CITY PLANNING COMMISSION

APPLICATION: A. Negative Declaration
B. Special Permit to allow 100 percent office use for three buildings totaling 159,200+ sq. ft. on 10.0 vacant acres in the M-1 zone.

LOCATION: West side of Redding Avenue, 130+ feet south of Madrone Avenue, East side of 4th Avenue.

SITE PLAN 1.00' 6' high masonry wall required

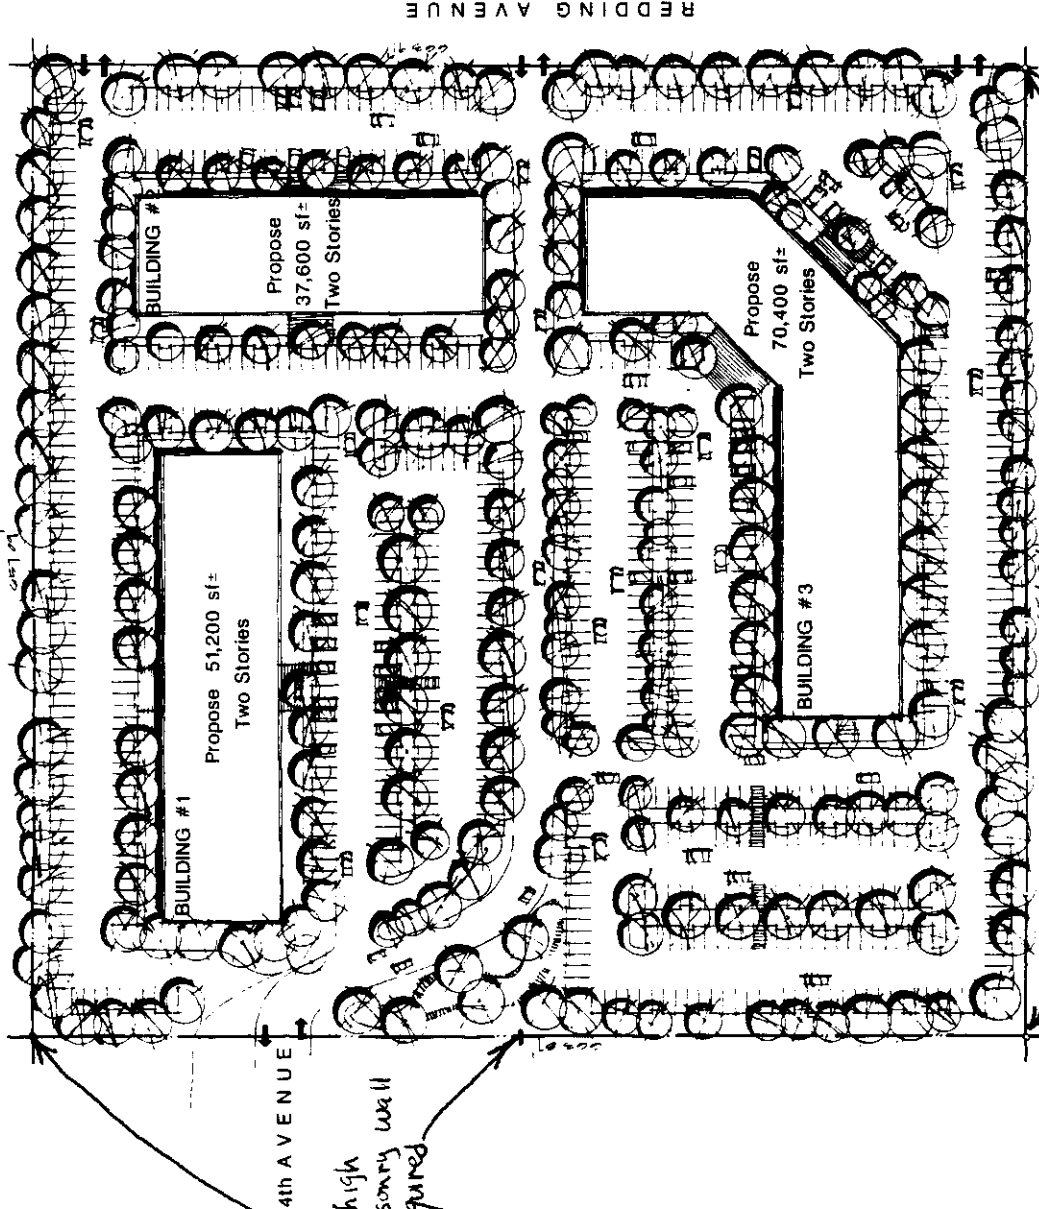
The site plan does not show the location of trash enclosures or the required Class I, II, bicycle storage lockers. The site plan needs to be revised to show the locations of the trash enclosures and bicycle storage lockers.

The building footprints proposed on the site plan do not precisely match the proposed building elevations. Staff recommends the site plan be revised to show more precise building footprints consistent with the proposed elevations.

The Zoning Ordinance requires a six foot high, solid masonry wall along the entire south property line of the subject site. This is because of the adjacent Standard Single Family (R-1) zone located south of the project site. There is also a multiple Family (R-3) zone located along a portion of the west property line (see site plan). A six foot high solid masonry wall will be required along a portion of the west property line (see site plan).

6. Revised elevations shall be submitted to staff for review and approval prior to the issuance of a building permit.
7. A revised site plan showing the location of trash enclosures, precise building footprints and bicycle storage lockers shall be submitted to staff for review and approval prior to the issuance of a building permit.
